DESIGN REVIEW RECOMMENDATION

SDCI # 3036955-LU
1118 & 1122 13th Ave
Seattle, WA 98122

Applicant:
Cone Architecture
1319 N 49th St
Seattle, WA 98103
Contact: Summer McEneny

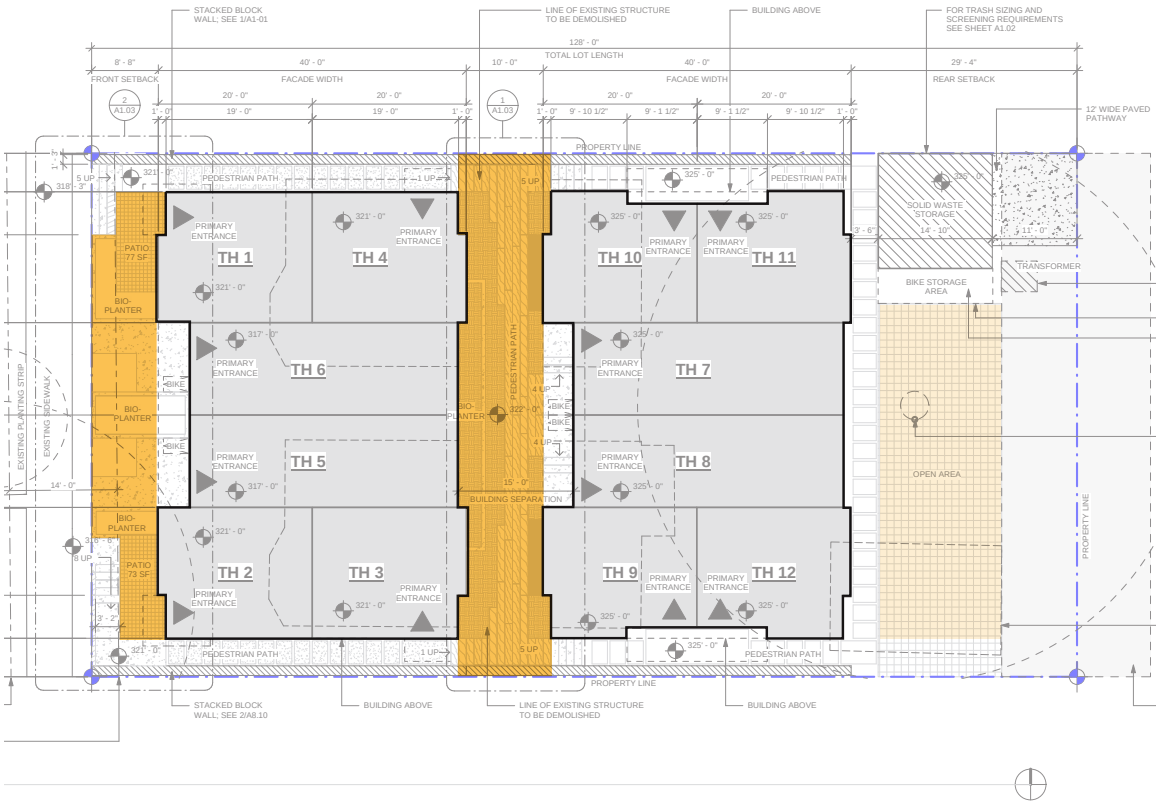
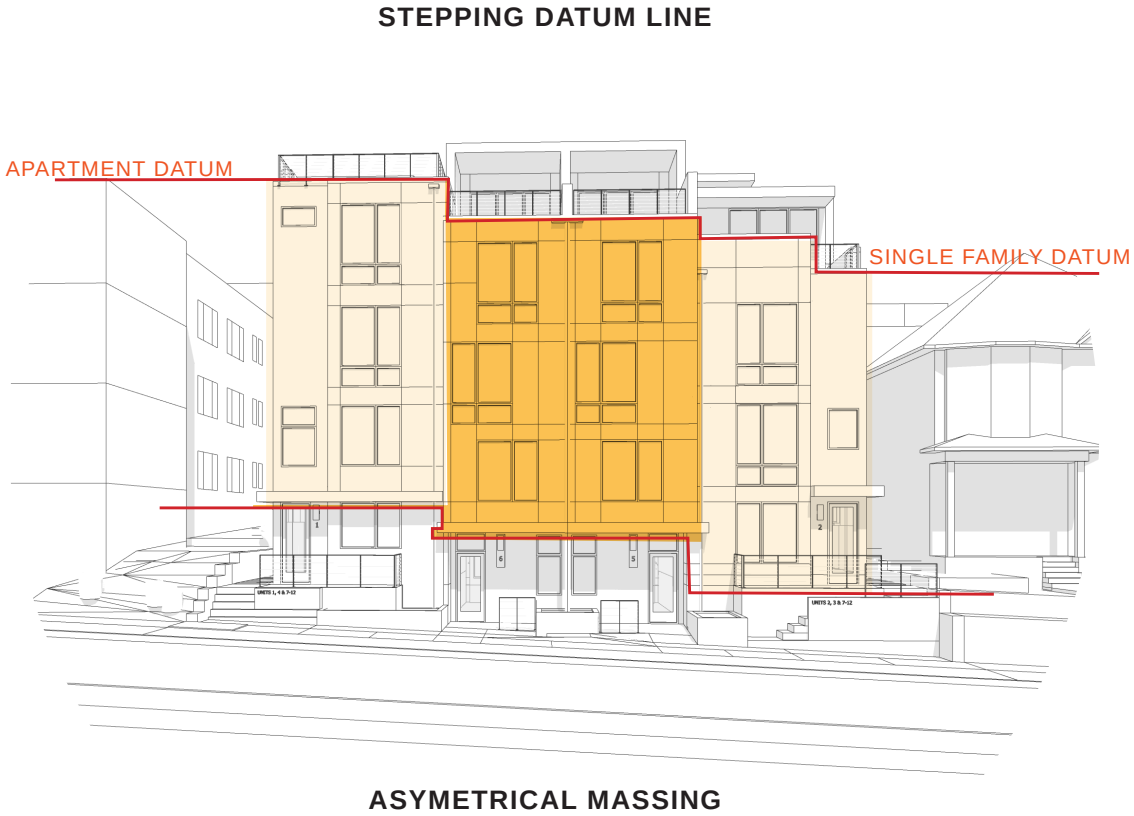
1.C. ...Staff recommends further development of Option 3, maintaining the increased building separation and front setback, while incorporating the successful aspects of Option 1:

i. Develop an asymmetrical street façade which responds to the datum line to the north and continues to step down to the single family home to the south, creating a reduction of bulk at the roof.

ii. Study how to incorporate usable ground-level amenity space, whether common space or individual patios.

MUP CY1 #5:
Staff supports the roof line changes to the west building which respond to EDG guidance and the datum lines of adjacent structures, stepping down to lower scale development to the south. However, this facade relies on in-plane material changes to create an asymmetrical composition which does not express the actual massing form. The material application further lacks a clear strategy when the brick cladding continues from the recessed entries to the base of TH 1. Further develop the form of the west façade to respond to EDG guidance to create an asymmetrical massing. Changes in material application must be accompanied by distinct massing shifts. Staff suggests using the stepping at the roofline to inform massing shifts.

The massing of the preferred option responds to both the datum line from the apartments to the north and the single family home to the south. The top of parapet wall on the northern unit aligns with the apartments, while the southernmost unit sits a full story lower to align with the single family scale. The planner's guidance has been taken into account and more stepping has been implemented at the west facade, by bringing the brick fully up the base of the northern unit and introducing open rail in the center units, allowing the stepping datum line to read at both the top and base of the building, as shown above. See diagrams on the next page for illustration of new plane changes introduced. The images to the right illustrate several of the ground level open spaces incorporated into the project, with a mix of both public and private uses.

LEGIBLE PLANE CHANGES AT MATERIAL TRANSITIONS

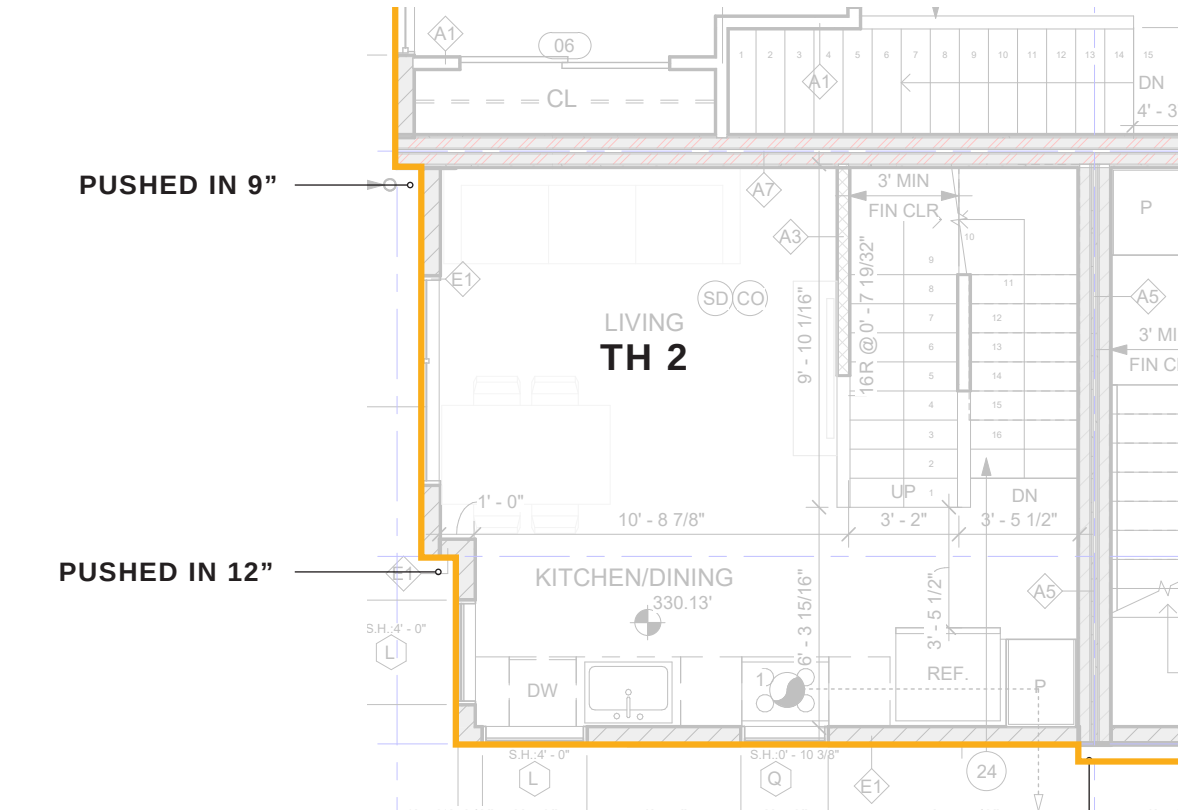
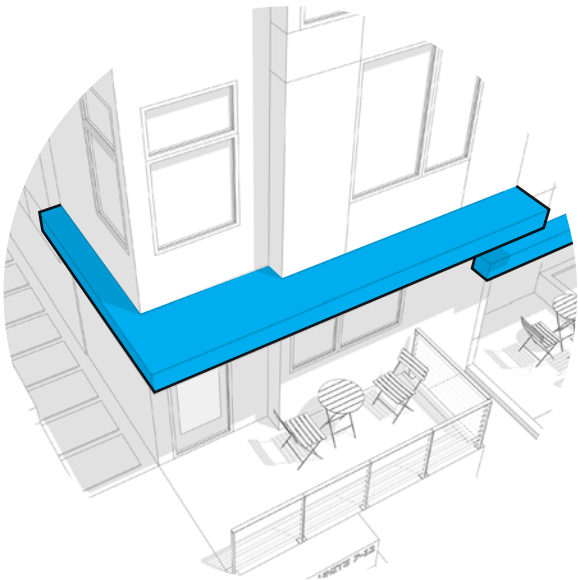
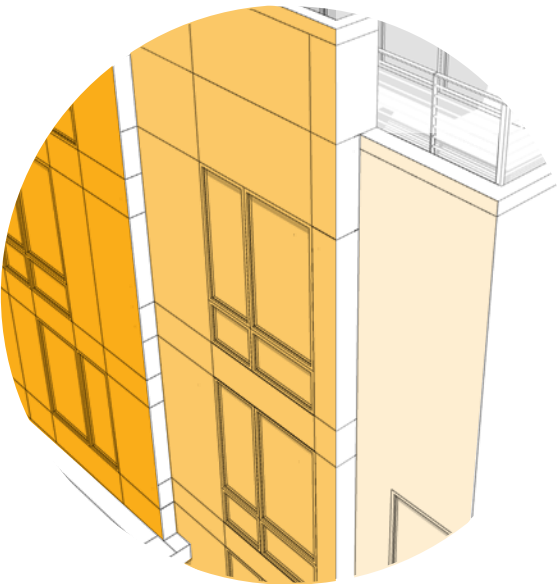
1.D. Option 3 introduces modulation at the ground level which is not continued at the upper levels resulting in long, flat walls. Avoid long, flat facades with vertical modulation and legible plane changes at material transitions. SEATTLE: DC4-3, CS2-1-c, DC2-1

MUP CY1 #8
At EDG staff provided guidance to avoid long, flat facades and provide legible modulation with material changes occurring at plane changes. Long, flat, unmodulated facades are proposed along the north and south elevations with numerous coplanar material changes. Staff appreciates the intent to break down the scale and mark program elements, but the use of belly bands or downspouts only appear as applied patterns and weaken the larger composition. Develop the facades with legible modulation at material changes.

APPLICANT RESPONSE:
Per the staff's guidance, the scale of the facade was further broken down by continuing to push and pull elements of the facade at material changes with legible modulation. In conjunction with the changes described on the previous page, on the west facade, both units have been pushed in (as seen in the plan diagram to the right) to create a change in plane along with the change in material. As suggested by the planner in MUP CY2, both corner units also include a change in material to gray. The two elements shaded in blue on the west facade that were previously belly bands have been extended into awnings, to create more depth and shadow, provide more weather protection, and better fit with the awning language throughout the rest of the project. Finally, to address the flatness of the north and south facades, a 6" deep furred rainscreen element has been added at material changes to create more depth and shadow, particularly around the window groupings and wood entry volumes.

13TH STREET FACADE
STOOPS AND GROUND
LEVEL AMENITY

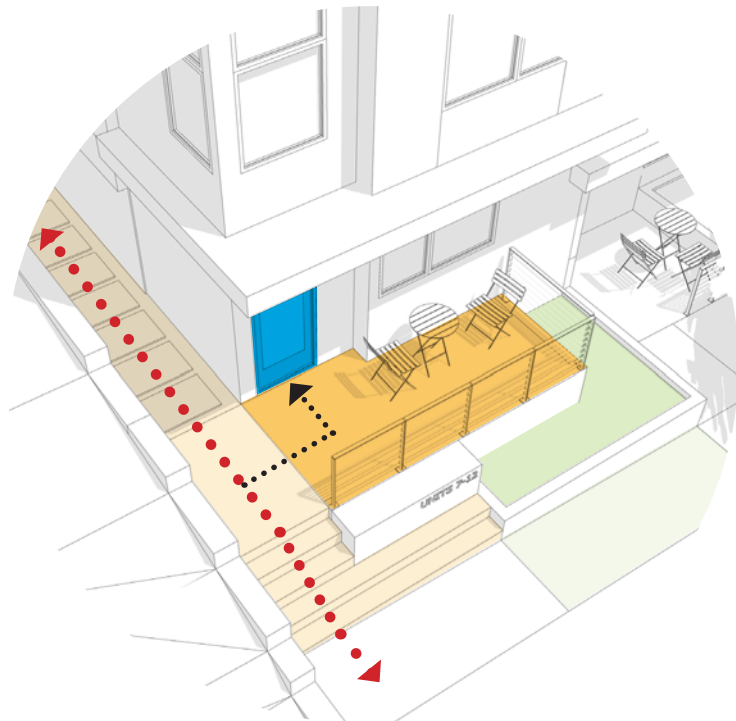
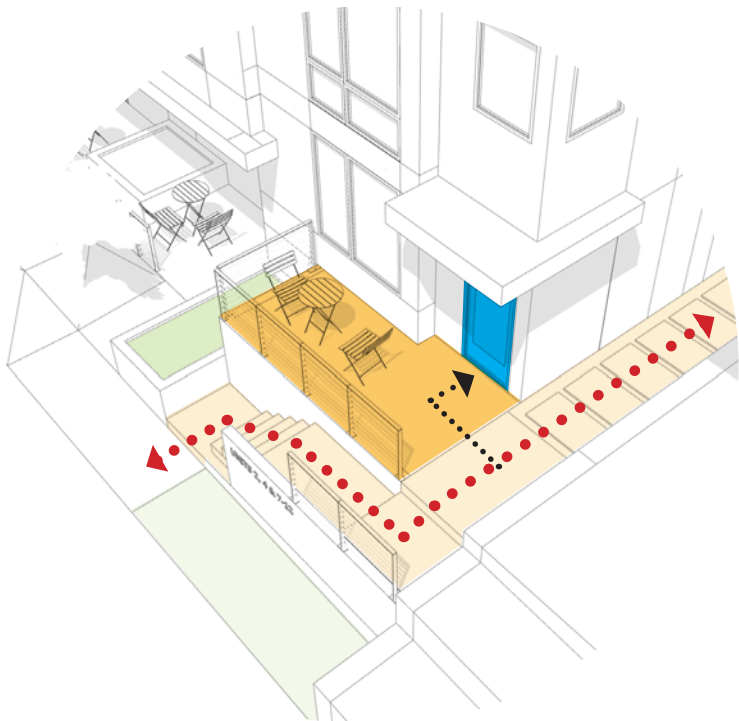
2.A. Staff prioritizes Design Guidelines PL3-2-i and PL3-2-j and provides guidance to develop usable and occupiable stoops or patios for the units along 13th Ave. Staff supports the precedent image on pg. 21 of the EDG packet (“stepping entry stoops”) to guide further development of the entries.
SEATTLE: PL3-2, CS1-1, PL3-1-g

2.B. Primary circulation for units without street access is immediately adjacent to the entries to the northern and southern street facing units. Design circulation and access to units at the rear of the site in a way that does not compromise the usability or private nature of the stoops along 13th Ave.
SEATTLE: PL1-1-a, PL3-1

2.C. In addition to providing usable stoops along 13th Ave, study the development of other usable ground-level amenity space as described under section #1 above.
SEATTLE: DC3-1, DC3-B

APPLICANT RESPONSE:
The concept with the front yard is two create two “community stoops” at the north and south sides of the site. Both will provide access to the common north and south pathways as well as access to the two corner units facing 13th. These larger community stoops provide opportunities for seating and allow all units in the project, not just the street facing units, to enjoy a street-facing stoop. While this might seem contrary to the guidance in item 2B, we believe it better meets the intent of design guideline PL3-2-I of the Central Area guidelines: “Encourage human activity by providing opportunities for neighbors to connect, walk, and talk together” as well as PL3-1-G “Provide coupled entries where possible to foster a sense of community and visual interest in building entryways.”
The central courtyard has also been further developed. A playful paver arrangement (mimicing the playful window concept) guides residents through this area. This space has been carefully designed to include pockets of landscaping, planters, window wells, and seating.

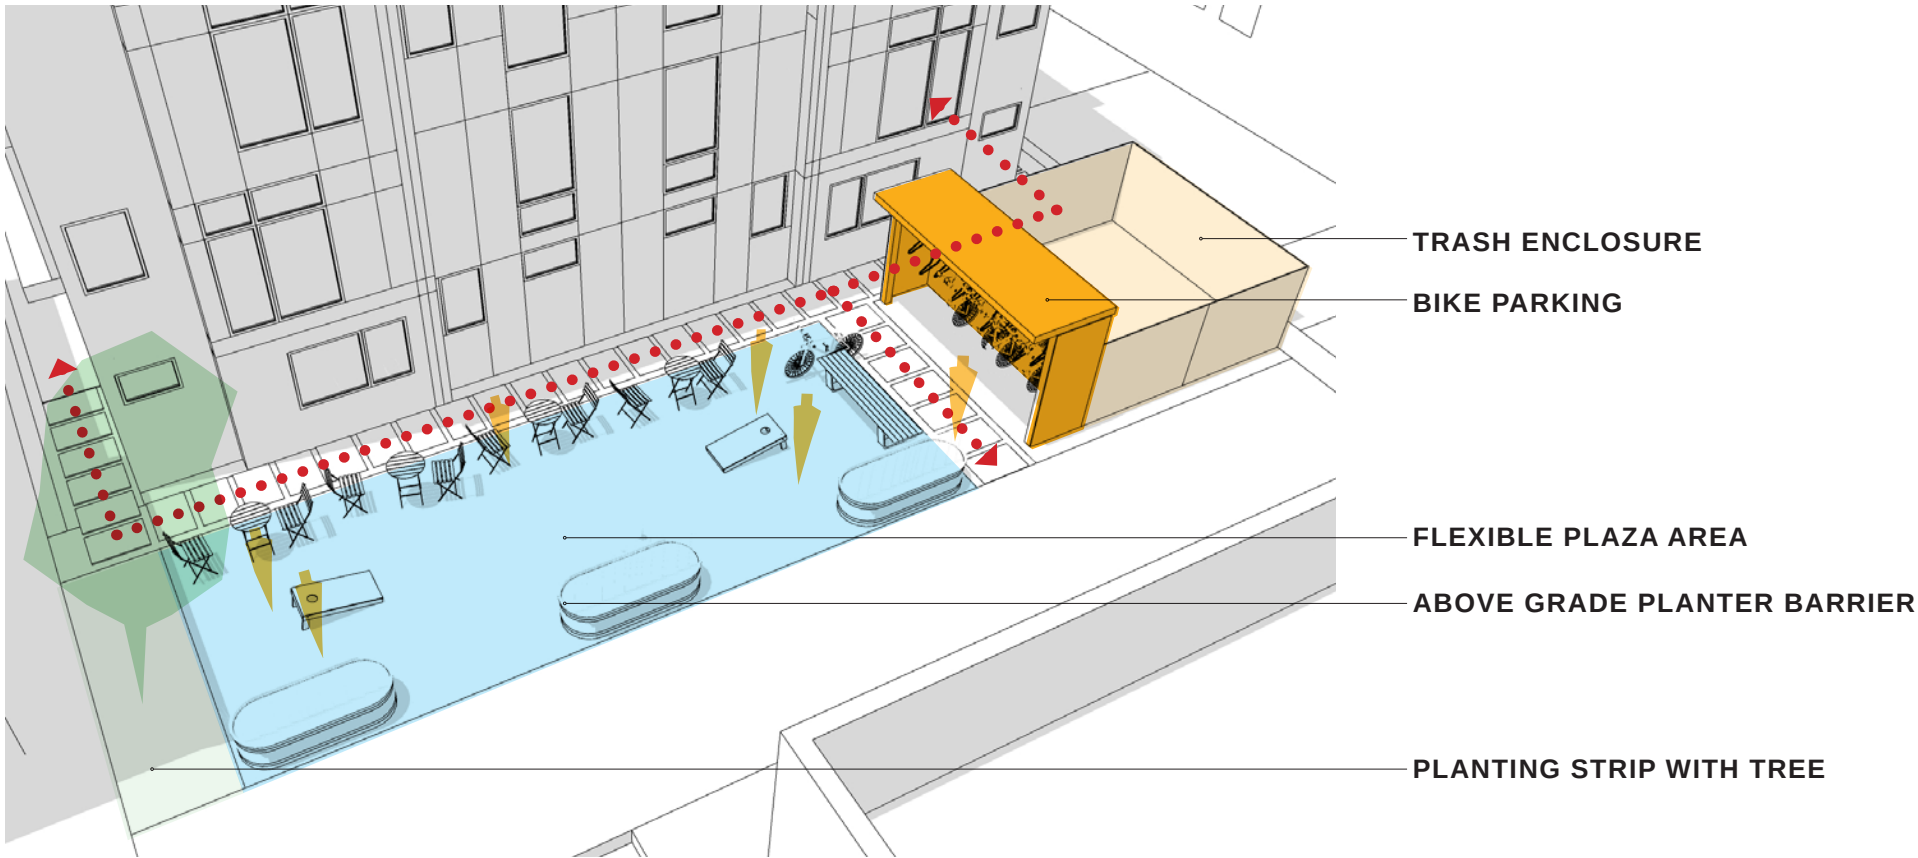
2.F. Staff supports locating parking and solid waste storage and collection at the rear of the site. Intentionally design the northeast corner to minimize the impacts of these uses and maximize the amount of landscaping.

It's unclear what is proposed for the rear of the site. The EDG packet indicated parking. If parking is no longer proposed, intentionally design this open space to serve a specific purpose and function and incorporate landscaping and buffering from the alley. Alternatively, if parking is not provided considering increasing the building separation and providing greater open space at the center of the site. If parking is proposed, show the parking on all applicable plans and provide landscaping buffering the rear units from the parking, as well as demonstrate the needed easements for access.

The northeast corner of the site has been designed with an enclosure to accomodate the sites solid waste and long term bike parking. Combining the solid waste and bike enclosure in the most compact way enables us to minimize the impact of the uses but also maximize the open area to the south. This space is planned to be a flexible plaza use to facilitate multiple types of activities, as illustrated to the right. We envision this as an actively used area that maintains the ability to walk / roll bikes across with a mix of hardscaping and landscaping, such as a grasscrete paver. The design includes a landscaped area with a new tree anchoring the southeast corner of the site and buffering the property to the south.

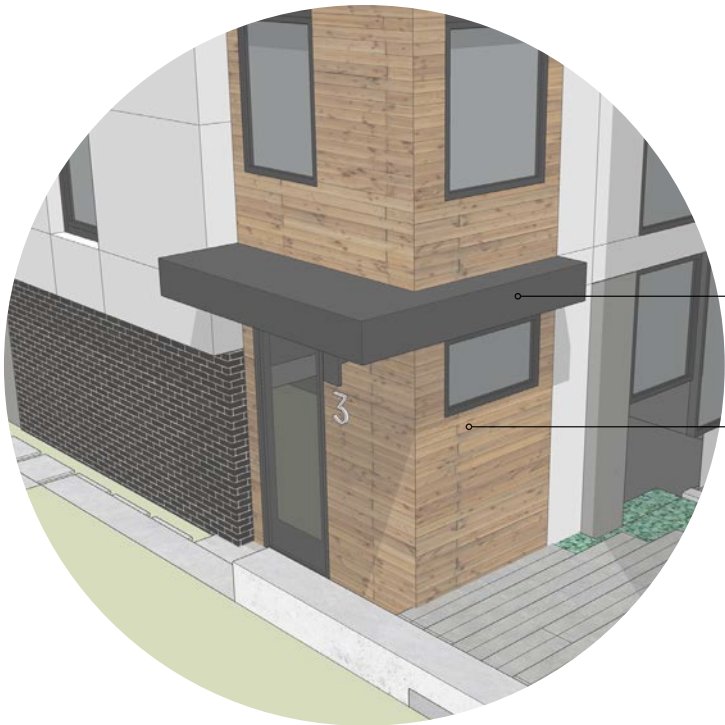
3.A. Incorporate secondary elements which provide human scale and façade depth. The use of an expressed party wall as indicated in the precedent images on pg. 45 of the EDG packet does not provide true façade depth.
SEATTLE: CS2-1-c, DC2-1-c, CS2-1-b, DC2-1-e

MUP CY1 #7
Maintain the recessed entries to townhouse units 3 and 4 as provided at EDG.

3.B. The precedent images indicate large groupings of windows, which is supported. (DC4-3-d Building Details and Elements)

MUP CY1 #6
The use of a staggered window composition on the west elevation is supported. However, the stepped floor plates creating stepping within the staggered pattern appears awkward as it does not relate to the overall massing form. Further refine the fenestration within this volume. In addition, continuing the staggered fenestration within the gray cladding does not support differentiating this as a separate unit/volume. Consider an aligned fenestration within the gray cladding similar to that used on other facades to differentiate this unit with a unique language, supporting an asymmetrical expression. Continue the use of a consistent fenestration language within cladding choices on building two.

APPLICANT RESPONSE:
Secondary architectural elements have been added throughout the project including open railings and awnings, covered decks with wood soffit, landscaping, signage and lighting. The entries to units 3 and 4 have been recessed again, which also helps address the north / south façade flatness as brought up in MUP CY1.

APPLICANT RESPONSE:
The windows have been arranged in large window groupings that vary in configuration between the massings of units. The groupings on the 13th Ave have a playful composition, emphasizing the stepping down motion relating to the overall massing. The planner's suggestion to align the windows within the gray units to further push the asymmetrical concept was a great one - we have implemented this throughout the project.

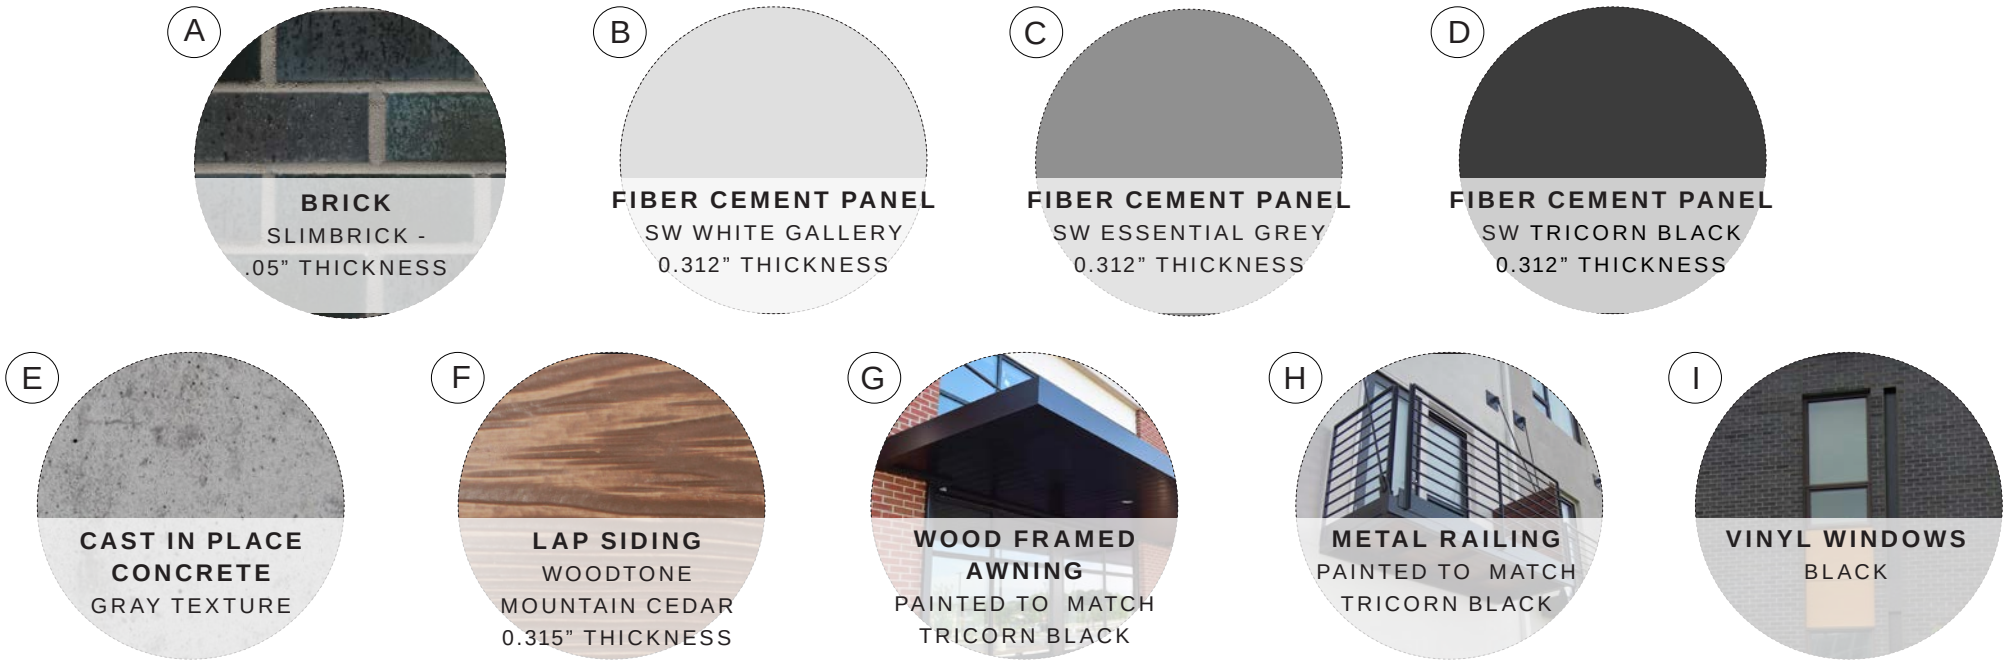
3.C. The precedent images also propose the use of wood siding, which is supported. The material palette should be primarily composed of high quality materials which reflect human scale and respond to the character of the adjacent structures.

3.D. The proposal is located in close proximity to development on the north and south. At the Recommendation phase, provide a privacy study which illustrates potential impacts to neighbors.

APPLICANT RESPONSE:
Per the staff's guidance high quality materials were selected to help reflect human scale at the ground level and respond the character of neighboring structures. Smaller scale high-quality dark tone brick is used at a majority of the unit entries closer to the ground level horizontal woodtone siding appearing at the building corners, address signage, and soffits

APPLICANT RESPONSE:
Privacy studies are provided to the right and within the MUP set.
